Office Action Summary

10/625,953

TOCHER, ANGUS J.

DETAILED ACTION

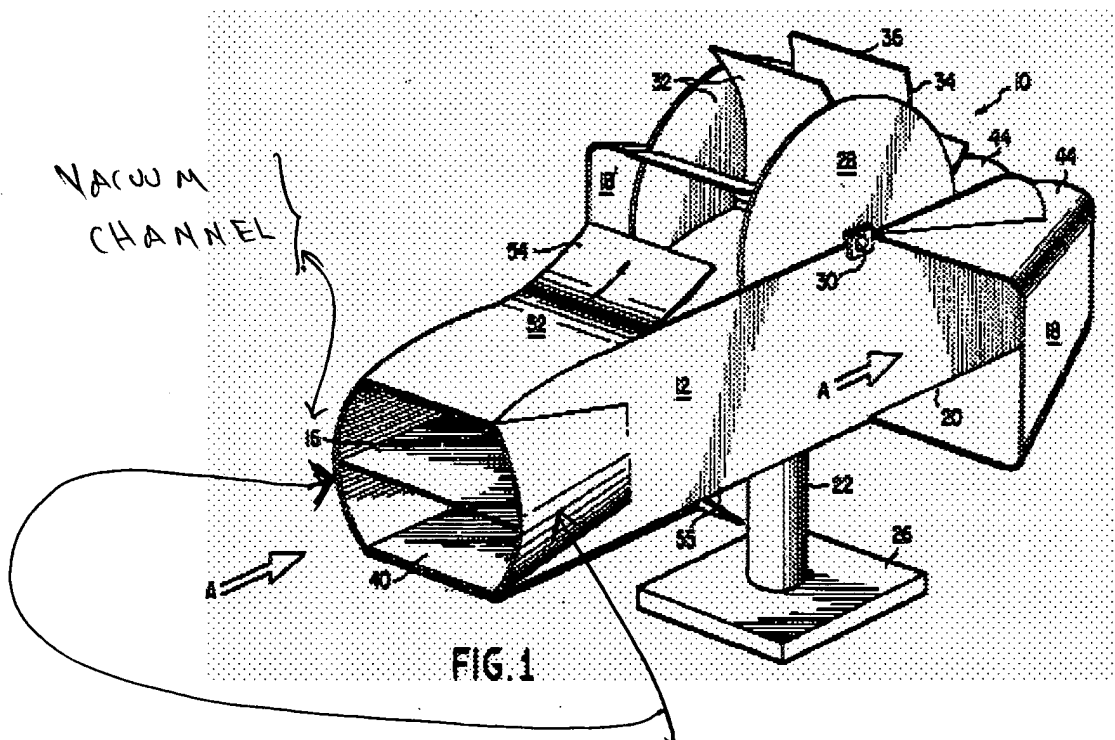
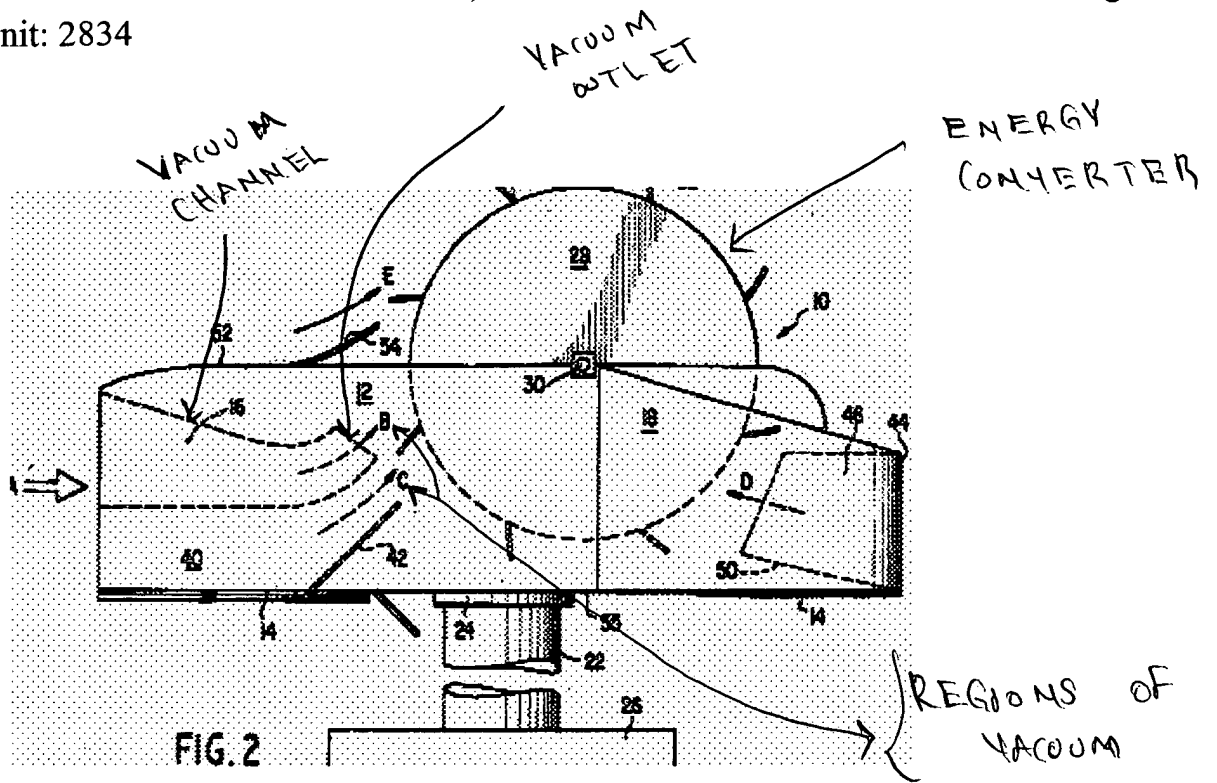
Kaufman discloses wind energy conversion having one or more vacuum generators. The vacuum generators disclose by Kaufman inherently accelerate the flow of wind since such device uses the Venturi principle (column 1, line 64; column 2, lines 8, 9, 51-53; column 3, lines 53-55).

Also, regions of vacuum B, C are induced (see figure 2) and one or more vacuum outlets are located in proximity to the regions of vacuum B, C. An energy converter 28 is used for converting the force of air drawn into the regions of vacuum B, C into usable energy (see abstract).

Moreover, a vacuum channel 16 is disclosed which supplies air to vacuum outlet and to regions of vacuum B, C (see figure 2). Also, Kaufman discloses inherently that some air is lead out (convey) of the converter 28 since half of the converter 28 is exposed outside the housing (see figure 1).

Kaufman further discloses that a framework 22, 55 supports and integrate all the elements into a single structure and the framework 22, 55 is able to place the wind acting on the framework to orient appropriately into the oncoming wind (column 3, lines 3-12).

VACUUM GENERATOR
(FUNNEL SHAPE SURFACES)

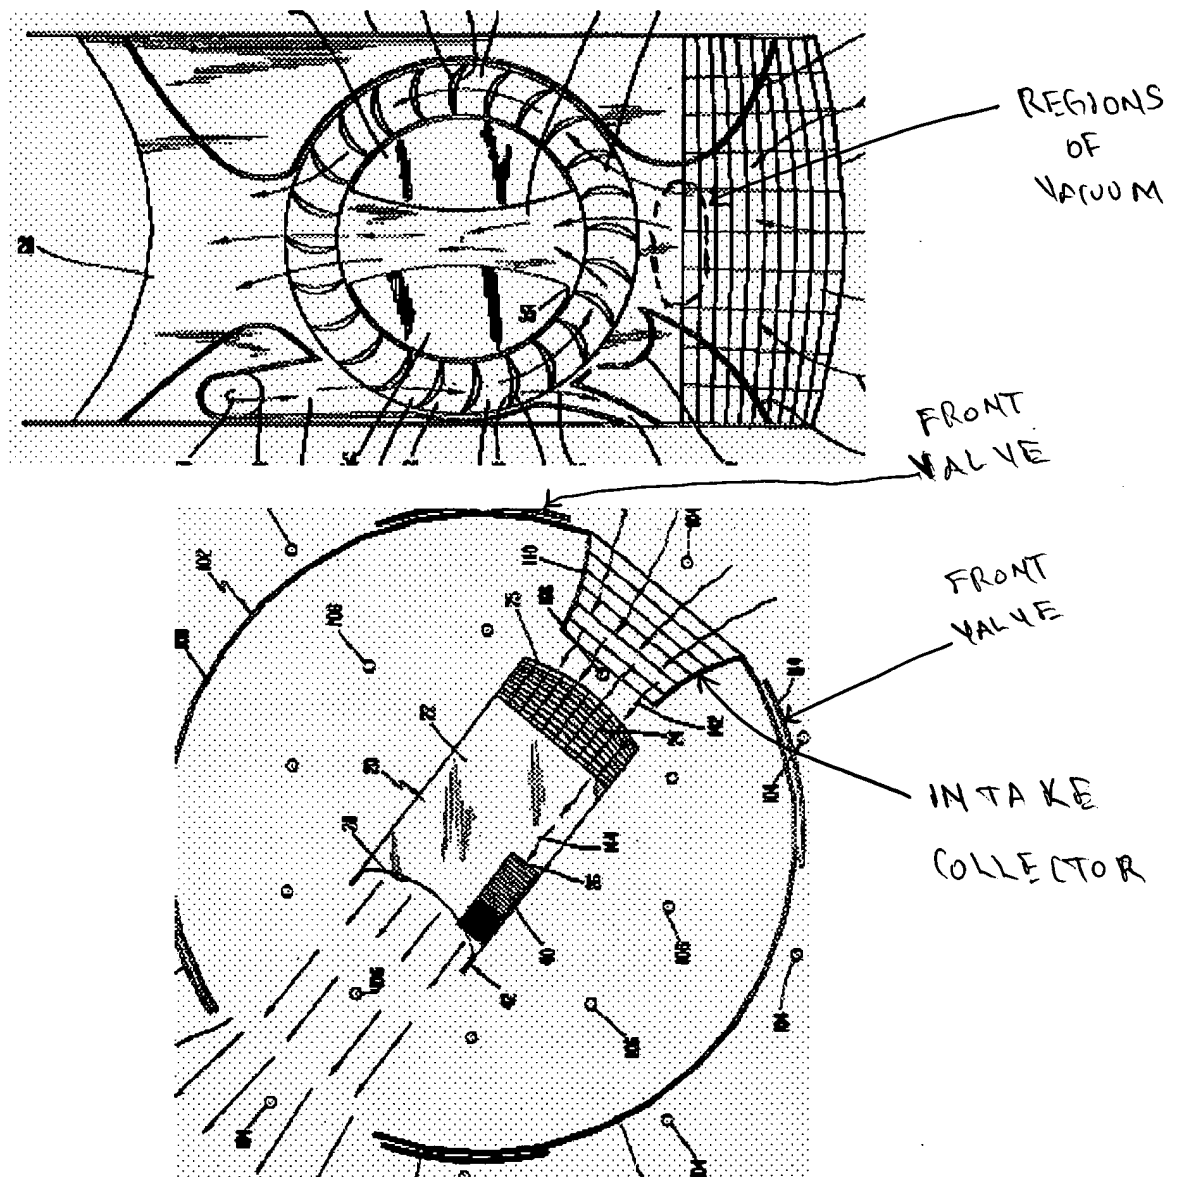
On the other hand, Lamont discloses for the purpose of increasing the mass flow rate of wind entering into a wind turbine, thus increasing output power, an intake collector 110, which supply a source of air to an energy converter 56 (see figures 2, 3, 9, 10, 14). Also, Lamont discloses using valves 120, 118, 116, 114, which control the flow of air into the regions of vacuum. (see figures 3, 8, 10; column 9, lines 1-13).

It would have been obvious to one having ordinary skill in the art at the time the invention was made to design a wind energy conversion as disclosed by Kaufman and to modify the invention by having an intake device for the purpose of increasing the mass flow rate of wind entering into a wind turbine, thus increasing output power as disclosed by Lamont.
